**HAMMAM AL ALIL DIVISION TRAINING
CENTER
MOSUL, IRAQ**

**SIGIR PA-09-174
JANUARY 7, 2010**

**SUBJECT: Report on the Hammam Al Alil Division Training Center, Mosul, Iraq
(SIGIR Report Number PA-09-174)**

Figure 4. Multi-purpose small arms range layout (Courtesy of USACE)

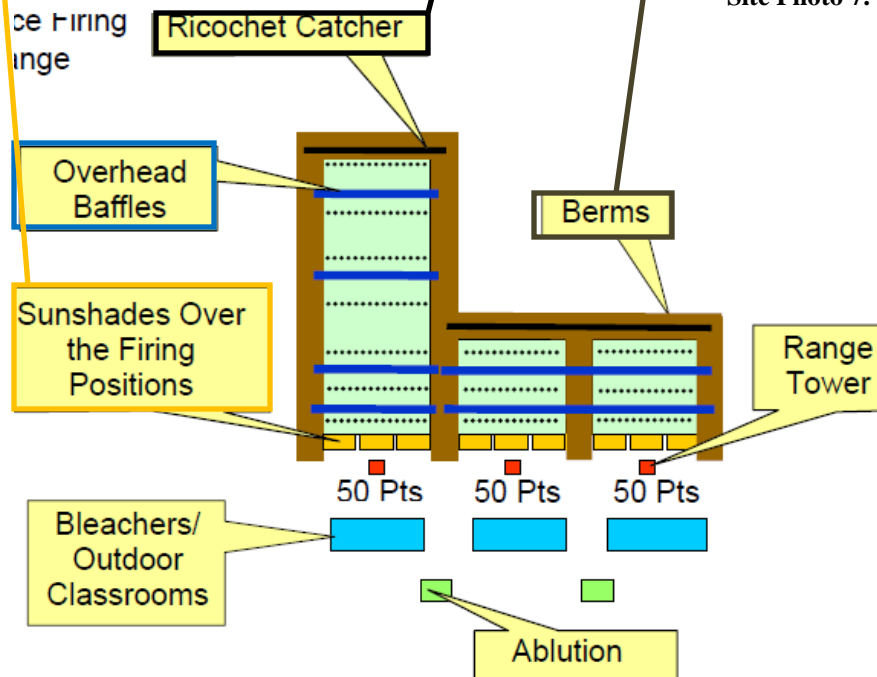
The SOW required the construction and installation of overhead baffles between the firing positions and the terminal end of the range (Figure 4). Overhead baffles were designed to contain all bullets fired from a prone or kneeling position. Also, the overhead baffles were designed to contain shots that would otherwise travel over the berm.

Due to the descoping of the overhead baffles, the multi-purpose small arms range was no longer considered a fully contained range. The GRN Mosul Area Office documentation did not address the status change of the range from a fully contained range⁶ to a non-contained range⁷. In addition, the documentation did not address the safety concerns of removing the overhead baffles or the impact on public safety.

In response to a draft of this report, the Gulf Region District of the U.S. Army Corps of Engineers (USACE) stated: “On 1 December 2009, the GRN Mosul Resident Office provided SIGIR documentation showing the chronology of events concerning the construction status of the range baffles and the customer’s decision to remove them. In addition, that the contractor’s program manager stated that the Iraqis, the end users, didn’t see a need for the baffles. The 30-foot berm at the terminating end of the range serves as the primary backstop. Further, the facility is located 24 kilometers south of Mosul in an isolated and sparsely populated area so the potential for collateral damage or injury is minimal.”
